CITY OF ALBUQUERQUE

October 9, 2018

RE: Maverik Fuel Center
3737 Princeton Drive NE
Grading and Drainage Plan & Drainage Report
Engineer's Stamp Date: 10/03/18
Hydrology File: G16D029

Based upon the information provided in your submittal received 10/03/2018, the Grading & Drainage Plan and Drainage Report **are not** approved for Building Permit and SO-19 Permit. The following comments need to be addressed for approval of the above referenced project:

ENGINEER'S SEAL	MAVERICK INC. STORE ALBUQUERQUE, NM	DRAWN BY pm
		DATE 10-28-18
	GRADING AND DRAINAGE PLAN	DRAWING 2018039-GR
		SHEET # C5
		JOB # 2018039
RONALD R. BOHANNAN P.E. #7868	5571 MIDWAY PARK PL NE ALBUQUERQUE, NEW MEXICO 87109 (505) 858-3100 www.tierrawestllc.com

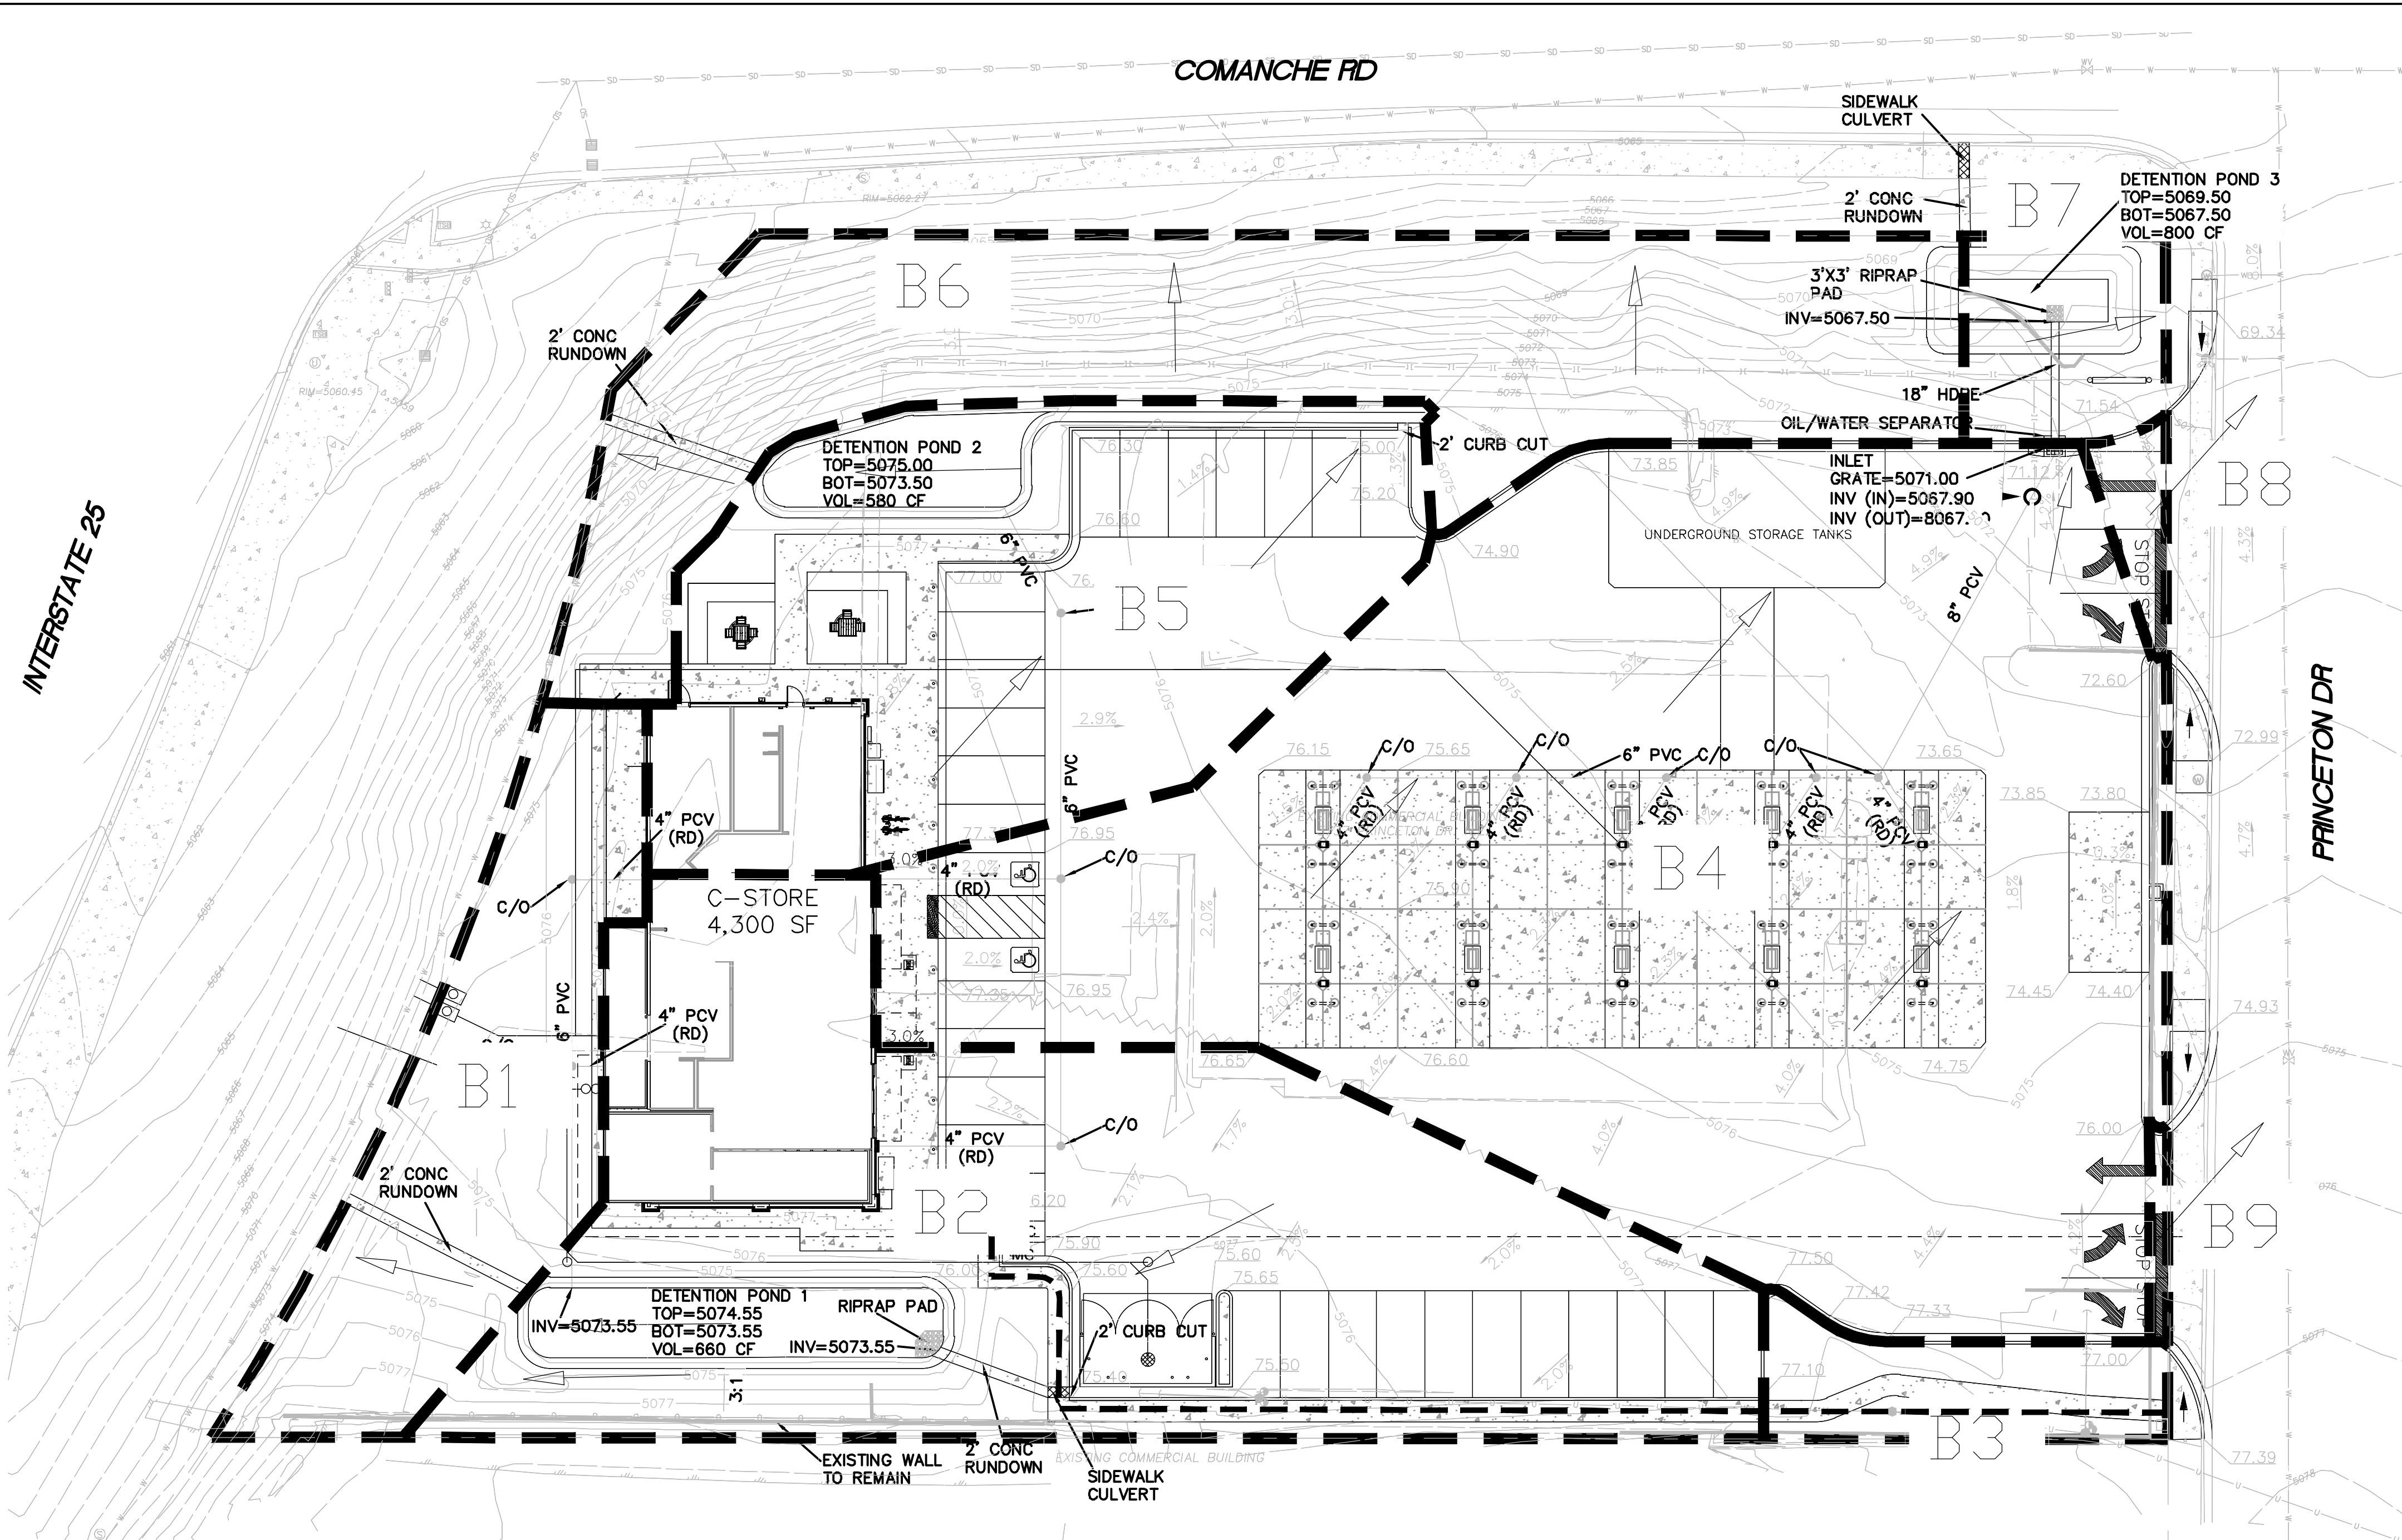
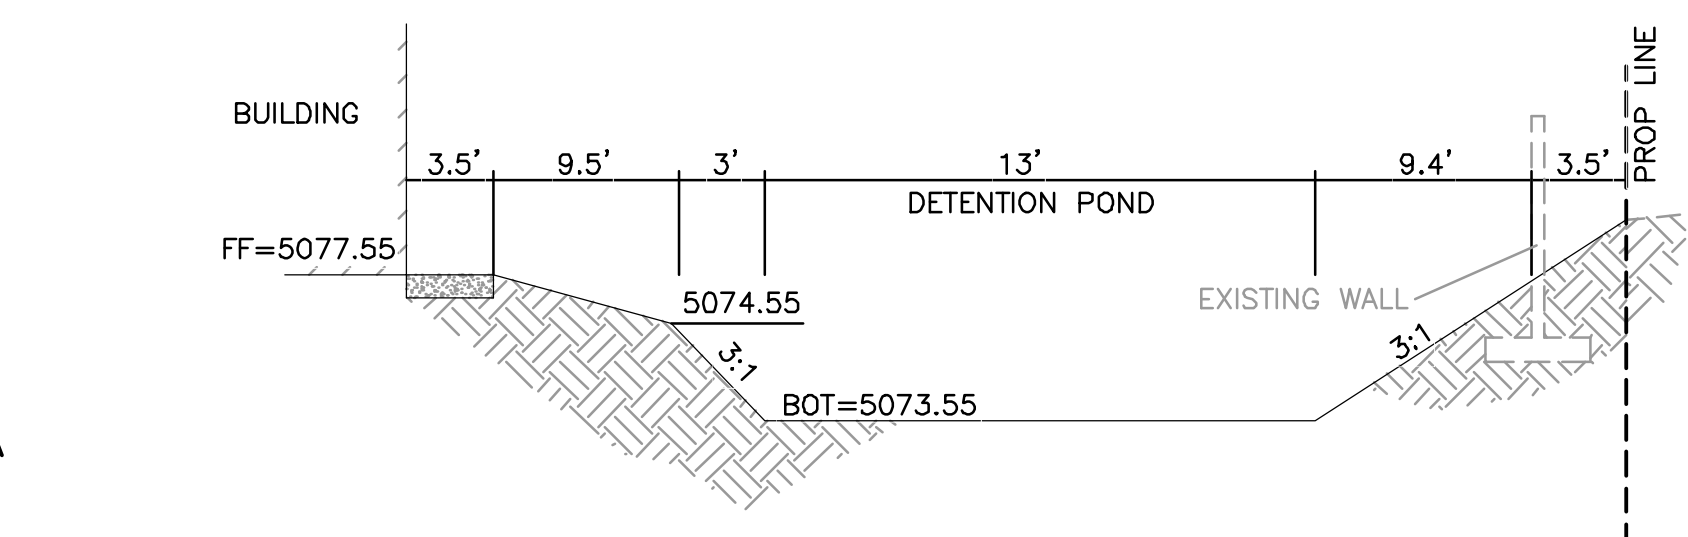
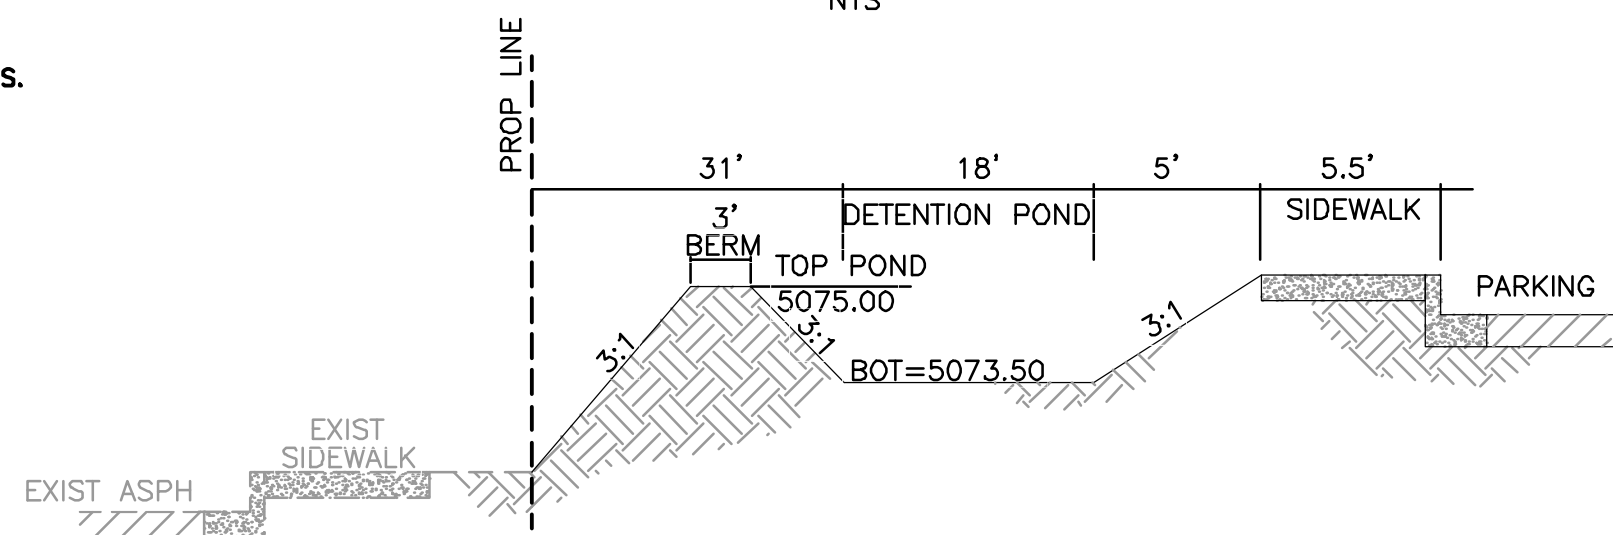
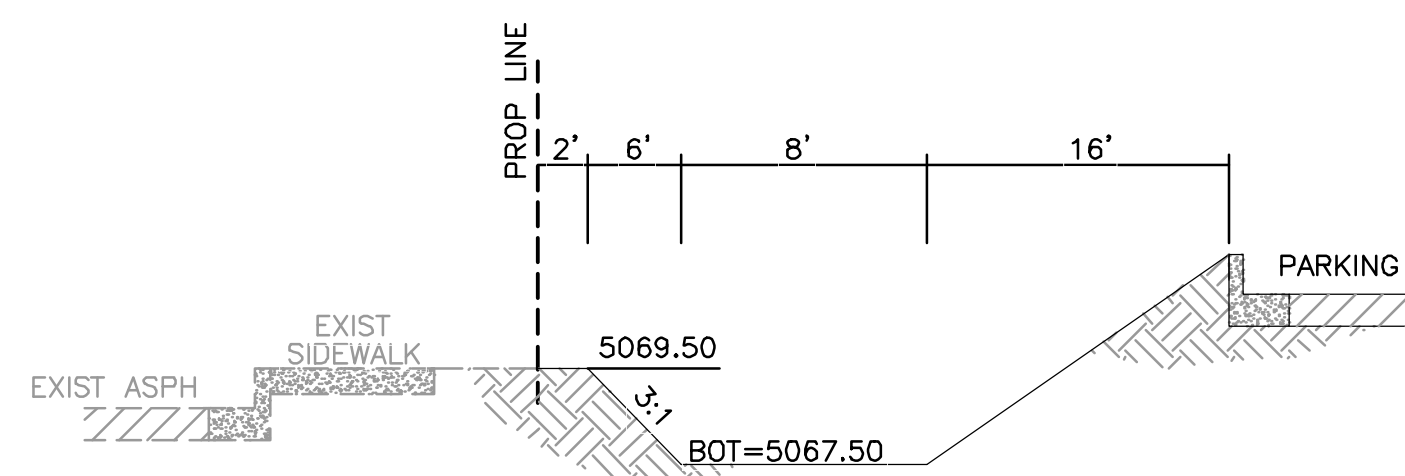
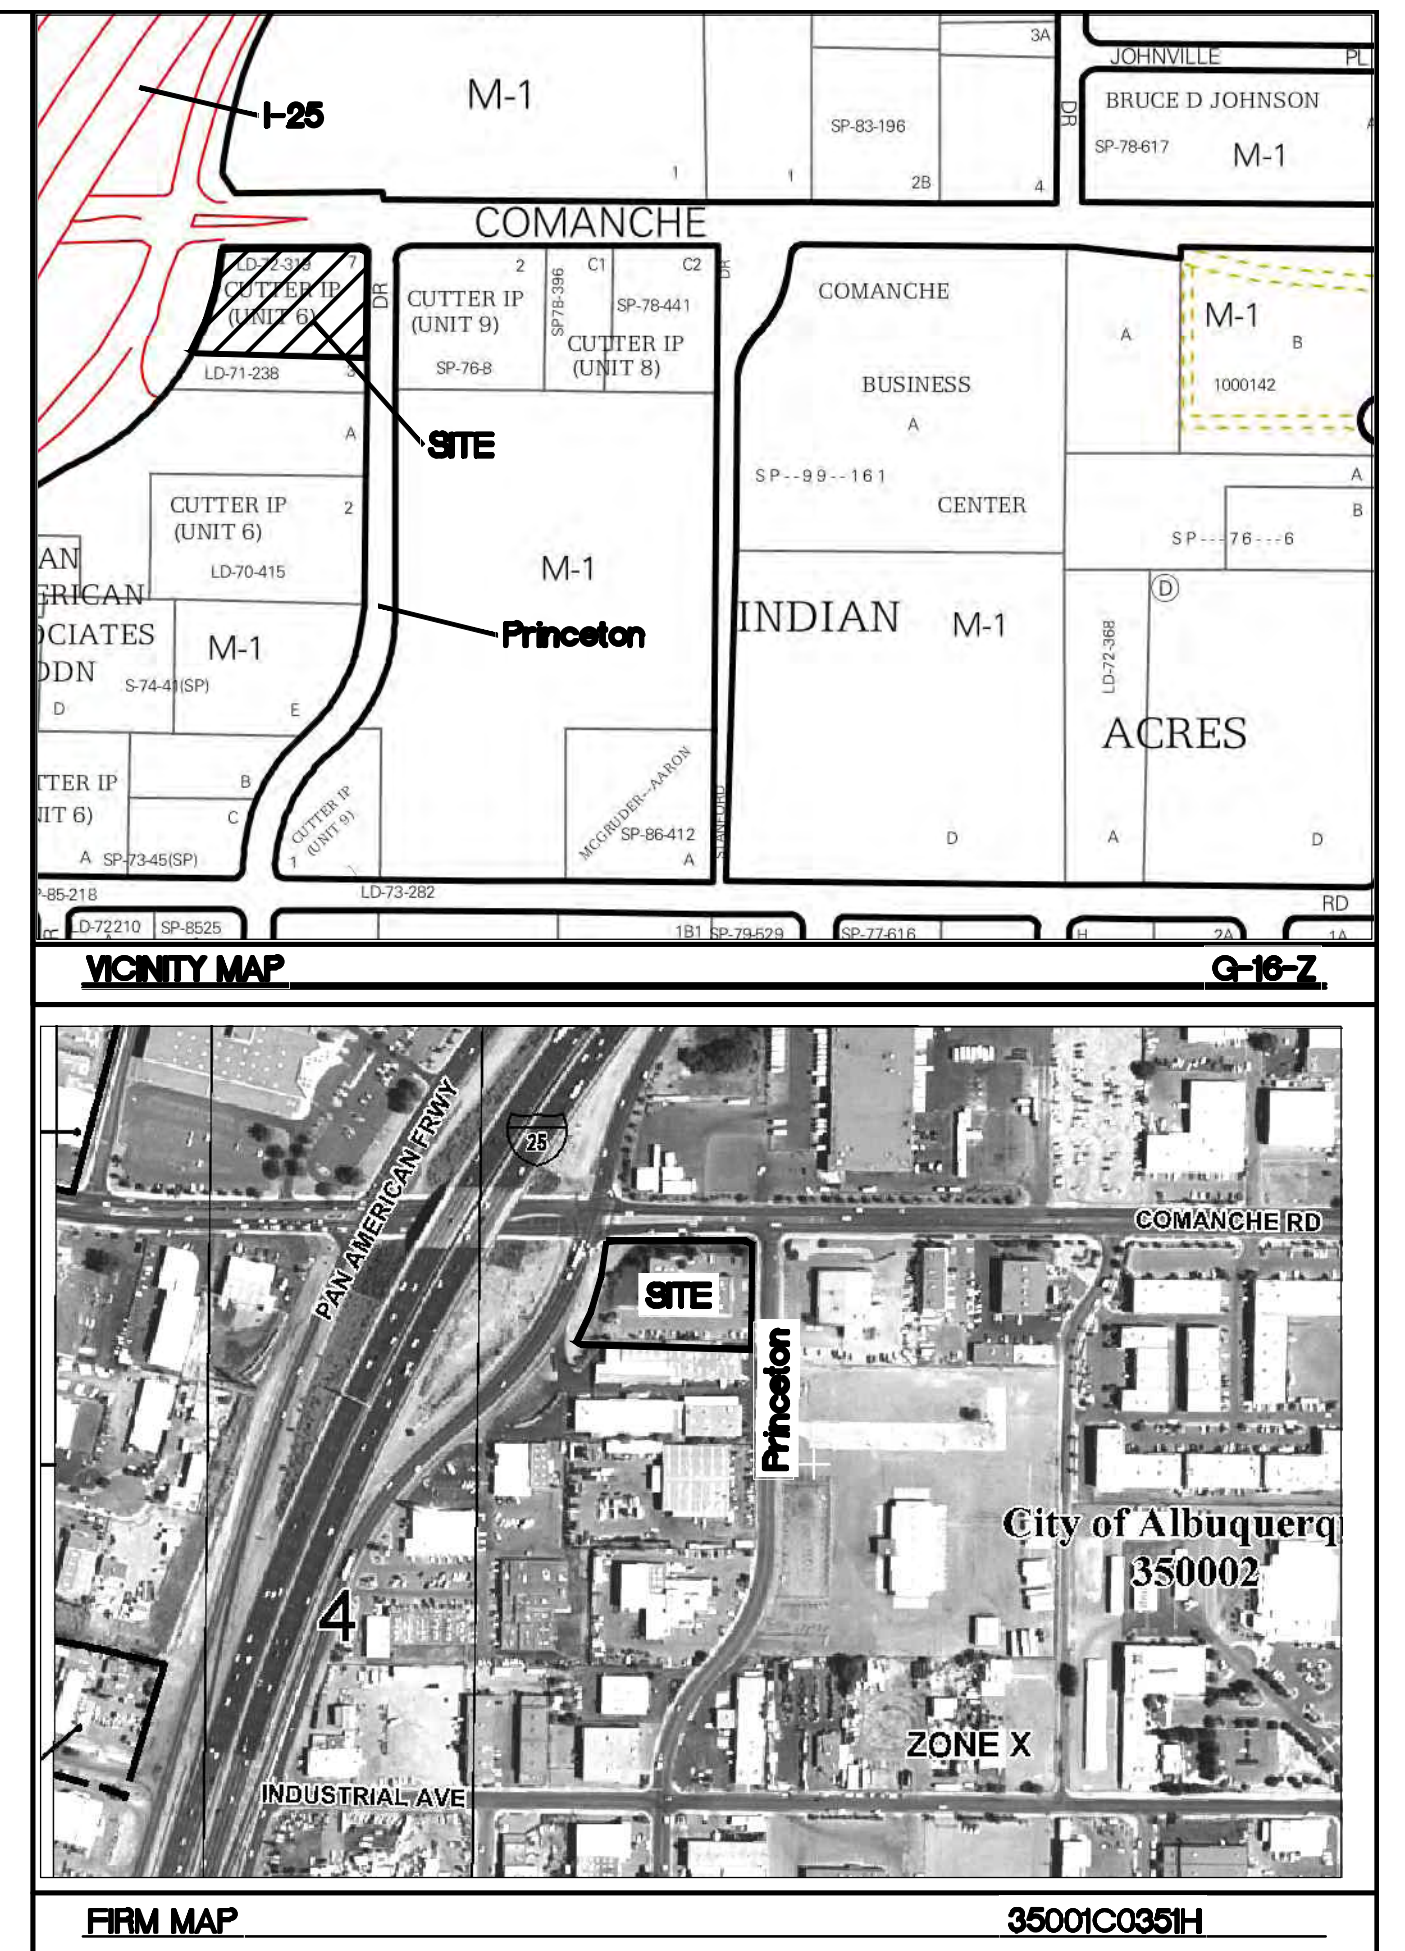
2. Sheet C5. Please provide the FIRM Map's effective date (8/16/12).
3. Sheet C5. Please provide the benchmark information for the survey contour information provided.

4. Sheet C5. Please provide the top of wall and bottom of wall (grade level) of the existing retaining wall at both ends and the middle. Since it appears that there will be some grading on both sides of the wall.

5. Sheet C5. In the water quality pond sections, please change the word "detention" to "water quality".
6. Sheet D1. Please darken the proposed storm sewer pipes so that they can be seen.
